Service Bulletin No. 1058

| COACH MODEL | : T2100 Series ; S2100 ; C2000 Series |
| SUBJECT | : Coolant and oil pressure warning light trigger signals |

Figure 1: Location of connector #123, on the right hand side rack, second row from the top.

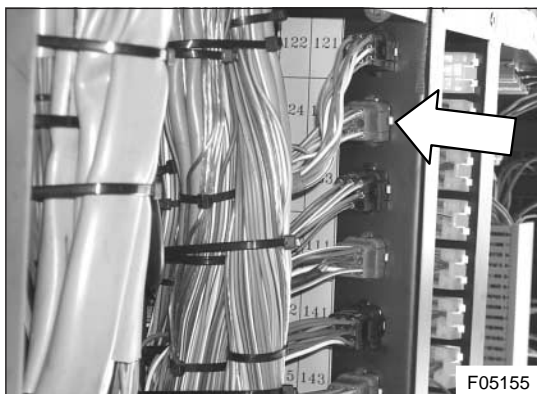
1. Park the coach on a level surface, apply the parking brake, shut down the engine, and install wheel chocks.
2. Switch off all systems and turn the battery master switch off.
3. Open the main junction box in the luggage compartment and locate multi-wire connectors #123 and #701 on the connector racks (see Figures 1 and 2).

4. Separate both these connectors and remove terminals #3 and #9 (receiver end) from connector #123 as described in the Maintenance Manual - Chapter 9 : Electrical System. Remove terminals #6 and #9 (receiver end) from connector #701.
5. Refit the connectors. Cut off the terminals from their respective wires (white-green & orange-white). Tie back the wires with tie-wraps.
